# EXPLANATION OF SIGNIFICANT DIFFERENCES (ESD)

GROVELAND WELLS NOS. 1 & 2 SUPERFUND SITE

Source Control/Operable Unit II

SEPTEMBER 2007

ERH Remediation Areas  
Groveland Superfund Site  
Groveland, MA

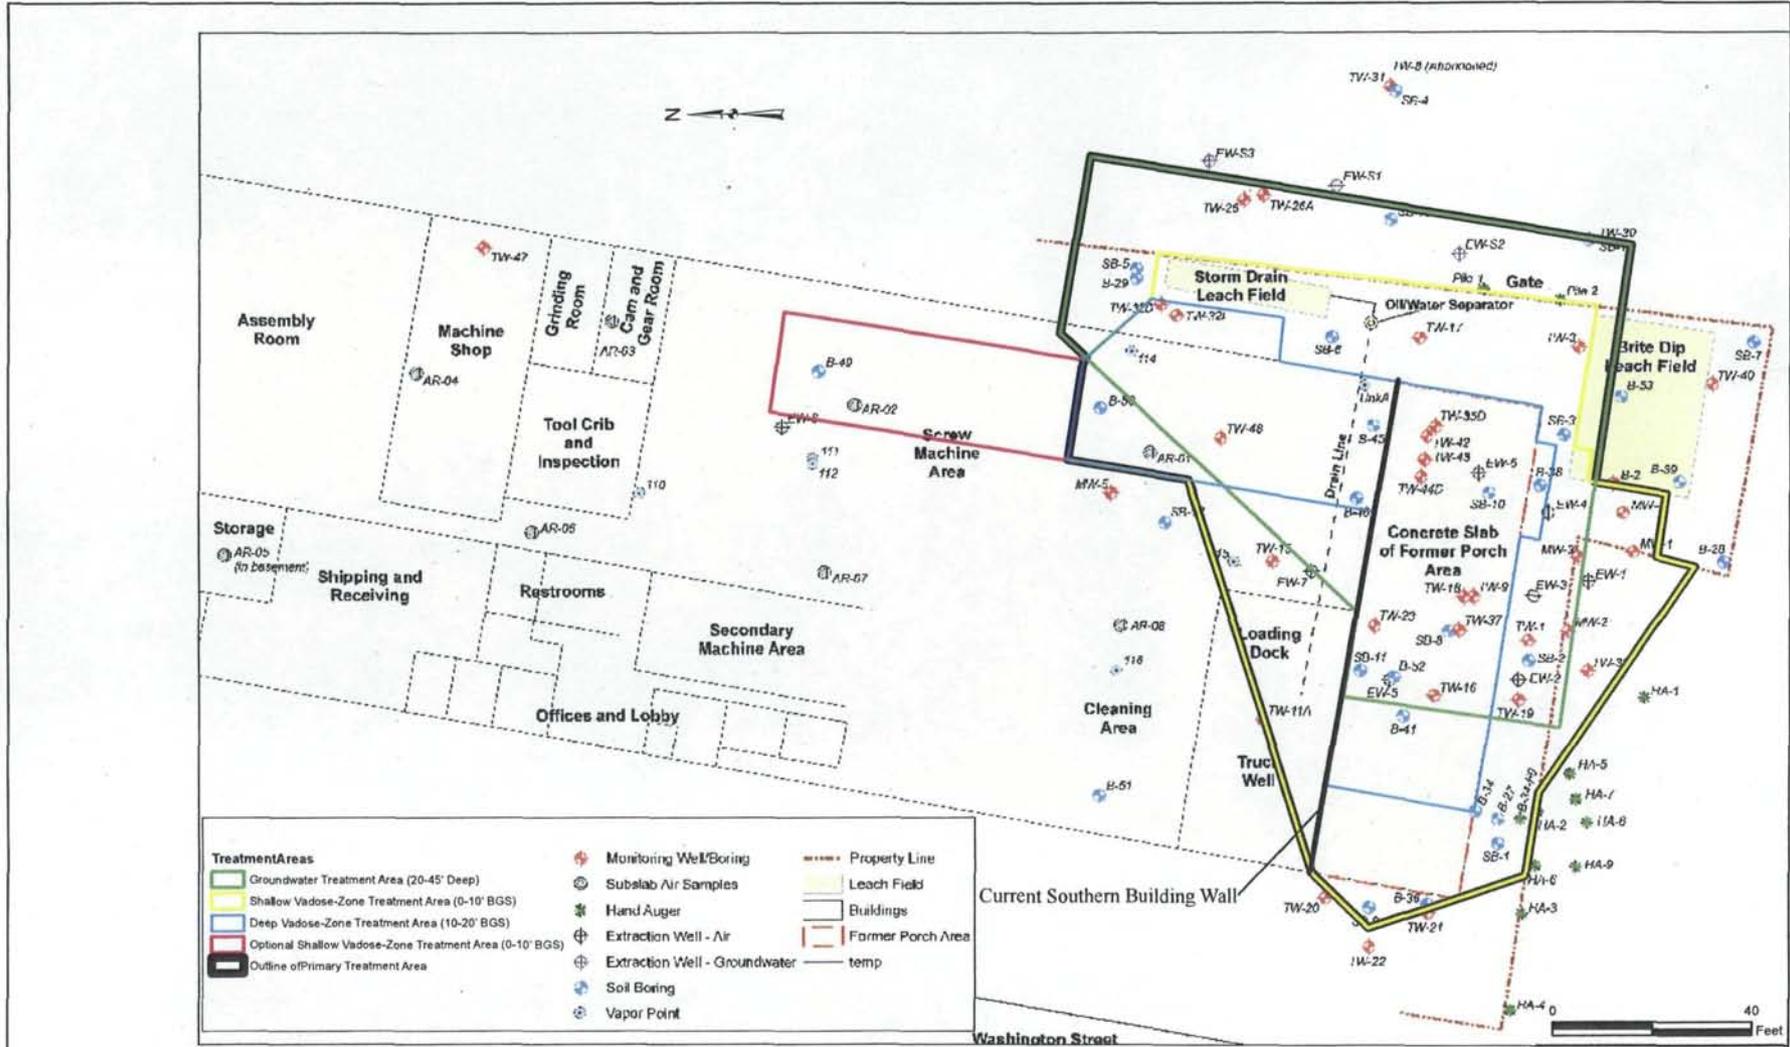
- In-situ thermal treatment with vapor extraction will be used to modify and enhance the SVE system for soil contamination. The contaminated vapors will be recovered with vapor extraction to more effectively remediate contaminated soils and thus reduce the long term operation and maintenance of the existing groundwater extraction, treatment and surface water discharge system.
- The soil cleanup levels for soil on the Valley property have been recalculated. EPA has recalculated the soil cleanup levels based on Site specific data and EPA guidance (See Table 2 and Attachment A). These levels will be used to confirm that residual soil contamination will not have an adverse effect on groundwater. The soil cleanup levels are protective of human health and the environment; and,
- The modifications of SVE will still meet ARARs identified in the 1988 ROD.
